Subject: Re: Anaconda Yerington Mine Site - ATSDR Investigation

Re: Anaconda Yerington Mine Site OU1
Comments on Background Water Quality Assessment Revision 2

EPA has completed its review of the following document: Background Groundwater Quality Assessment, Revision 2, Yerington Mine Site, July 2, 2015. While EPA appreciates the data analysis presented in the report, we have performed a supplemental data analysis which leads to different conclusions in some areas. Therefore we believe further refinement is necessary. Determination of background levels is key to forthcoming project stages, such as alternatives development under the

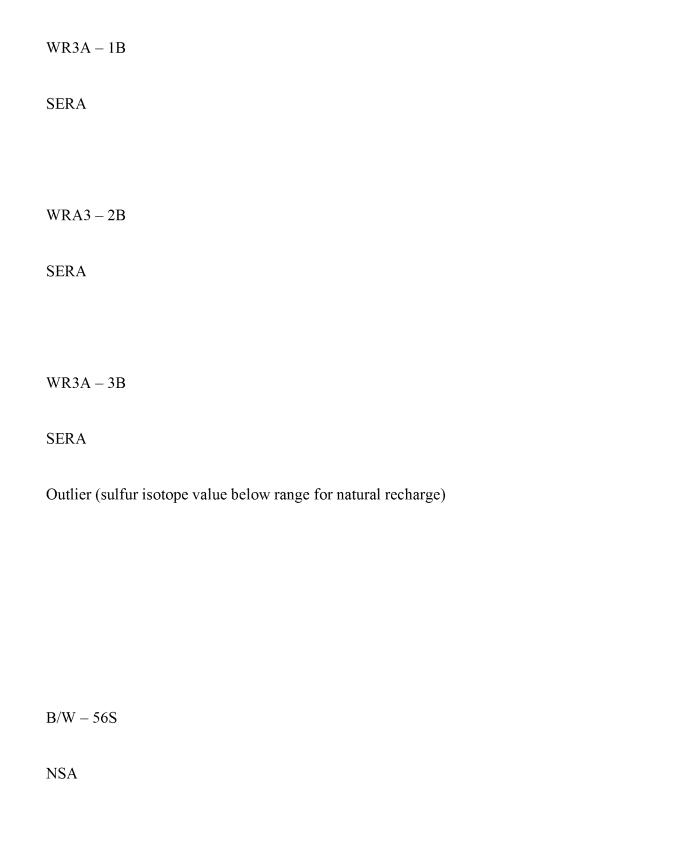
Feasibility Study. EPA would like to see a further revision of this document. Please see the following introductory comments as well as the attached detailed comments. We would appreciate a response to comments. We are available for detailed discussion with the ARC team and technical stakeholder group on this topic. Introductory comments: * EPA applied additional constraints toward the selection of background wells as detailed in the following table: ARC APPROACH EPA COMMENTS / ADDITIONAL CONSTRAINTS Spatial Location Site-Specific Hydrogeology **Examine Datasets for Outliers** Examine Datasets for Temporal Trends / Stationarity
